**WWTP Aeration/Mixing Equipment
ADDENDUM No. 1
January 24, 2019**

**THIS CONCLUDES ADDENDUM NO. 1 TO RFP NO. GS-2018-0068-
WASTEWATER TREATMENT PLANT
(WWTP) AERATION/MIXING EQUIPMENT**

**ATTACHMENTS TO ADDENDUM:
DRAWING NO. S201R
BYPASS AERATION BASIN DRAWING**

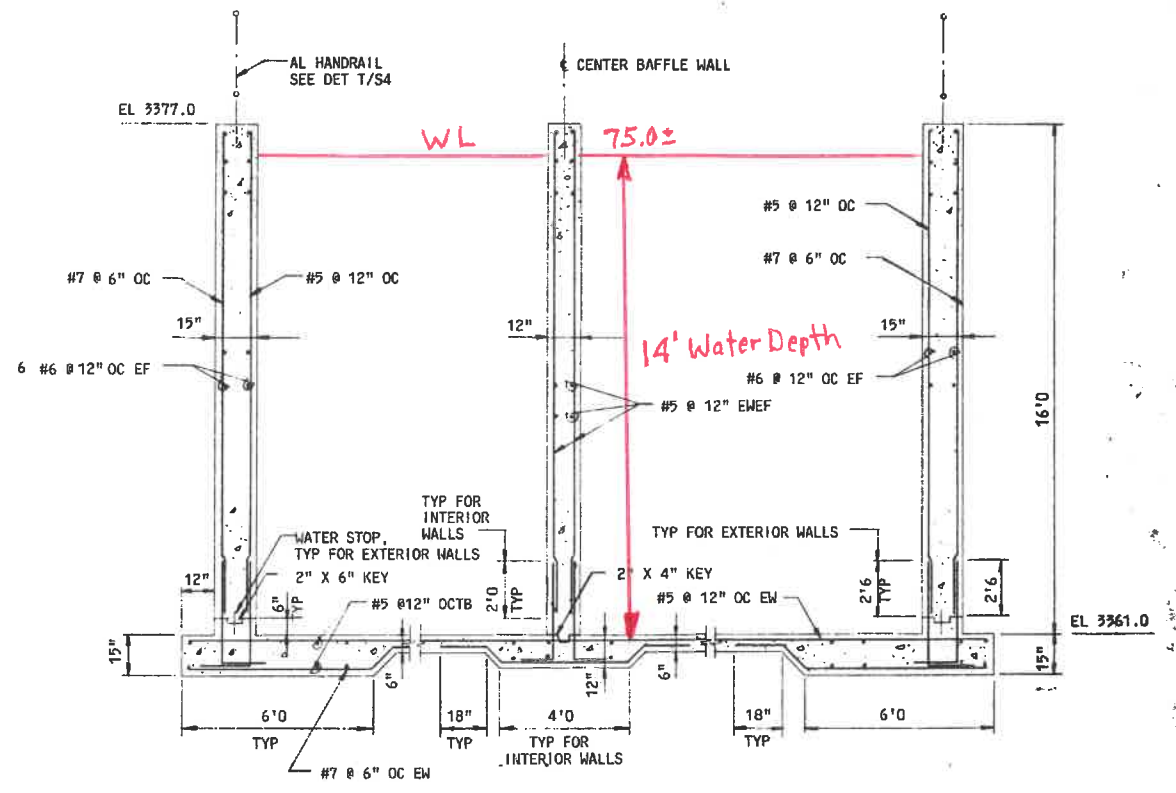
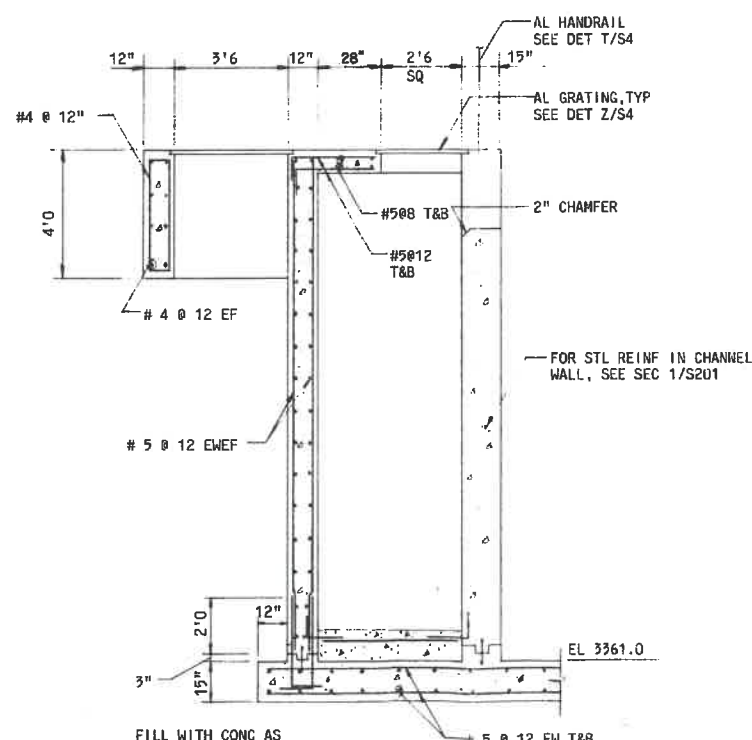
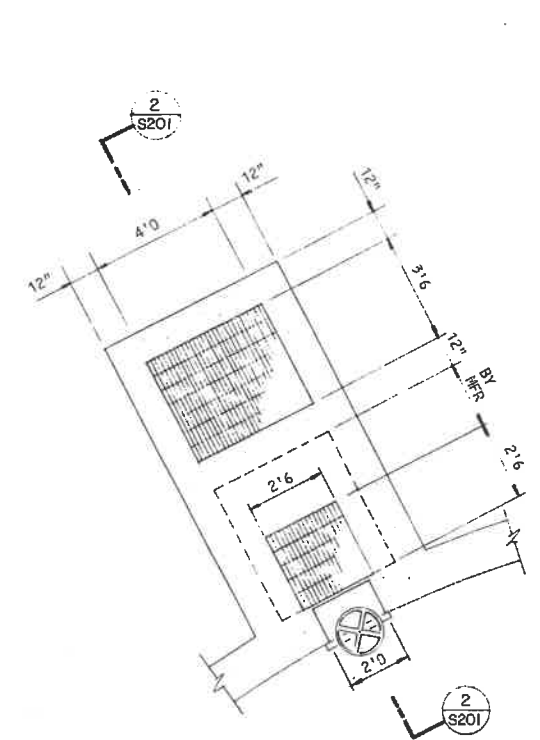
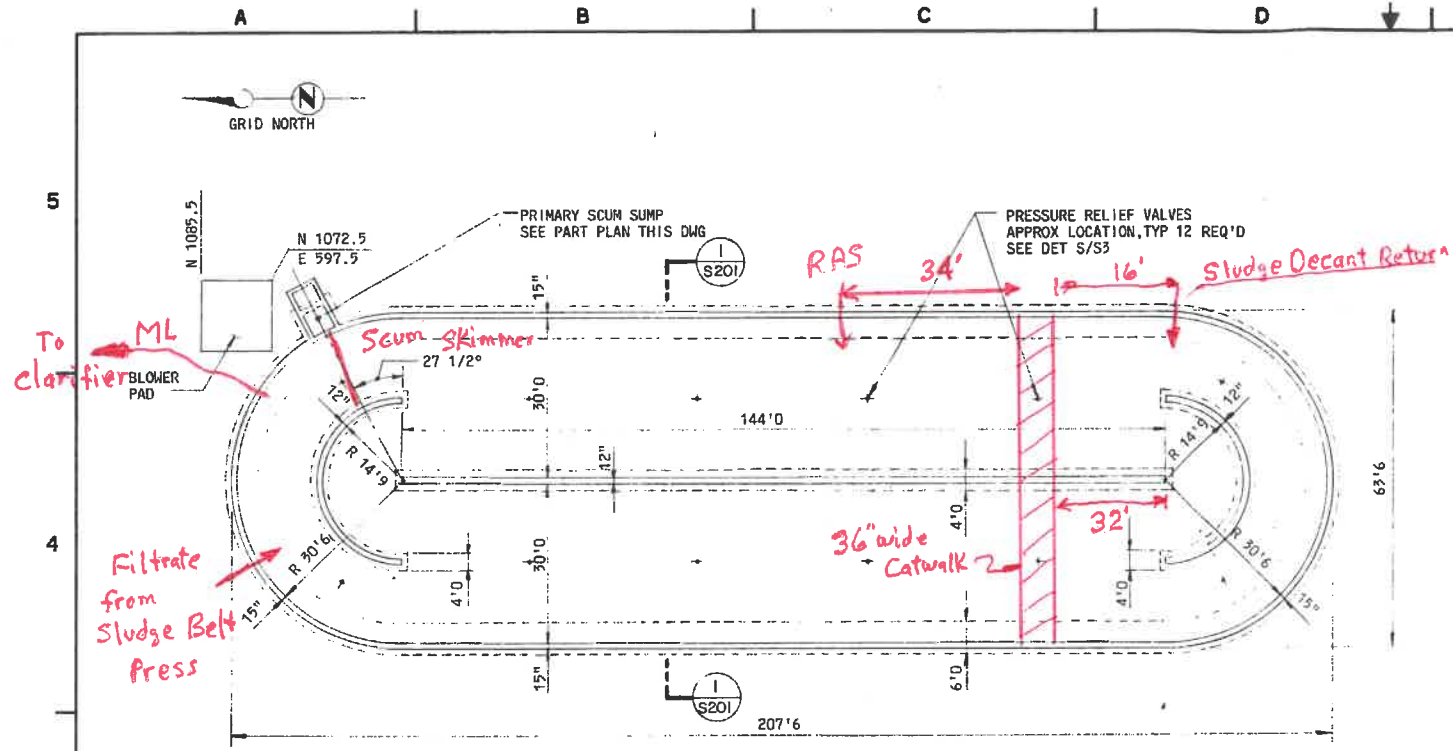
10. Are there any drawings available?

11. Based on the way the spec is currently written there must have been a system layout that was developed based on the Xylem Bioloop system?

A drawing of the existing oxidation ditch is included in this addendum.

Each vender must create a system layout to match their equipment with the existing facilities.
